City of Richmond
Planning and Development Department

Report to Development Permit Panel

To: Development Permit Panel
From: Brian J. Jackson, MCIP
Director of Development
Date: September 8, 2010
File: DP 09-494270
Re: **Application by Matthew Cheng Architect Inc. for a Development Permit at 8091 and 8131 No. 2 Road**

Excerpt from the Minutes from
The Design Panel Meeting

CONVERTIBLE UNITS (UNIT 9 AND 10) GROUND FLOOR PLAN TYP.

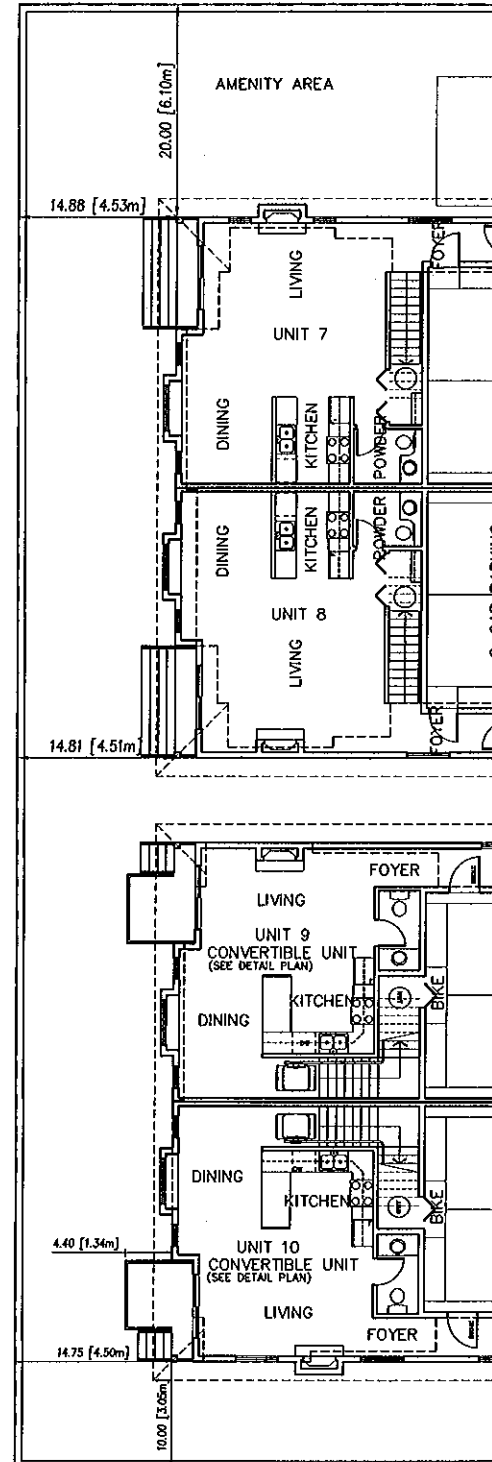
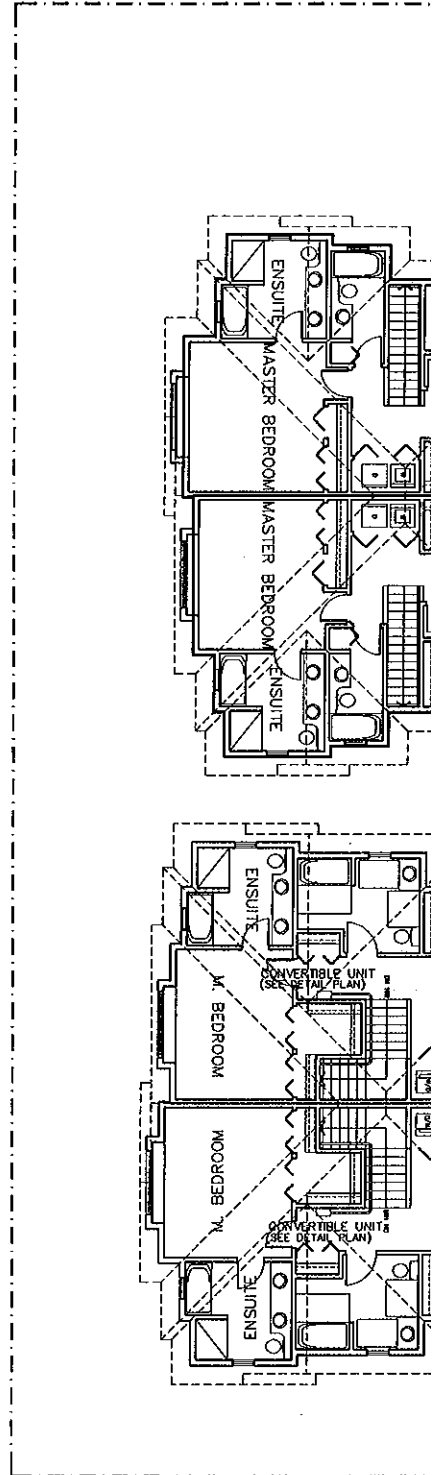
10. Consider improving convertible unit design and consider (i) vertical lift, (ii) sliding door at ensuite washroom, and (iii) angling of minor bedroom doors to increase manoeuvring room in hall;

There is no functional space for a vertical lift for this project so a chairlift is proposed. Further investigation on a functional unit design that includes a vertical lift will be undertaken for future projects.

Sliding doors are not long lasting and are easily broken. In this project, the space is large enough to avoid a sliding door.

The doors to minor bedrooms have been pushed in towards the room to create a wider hall (4' wide instead of 3' wide).
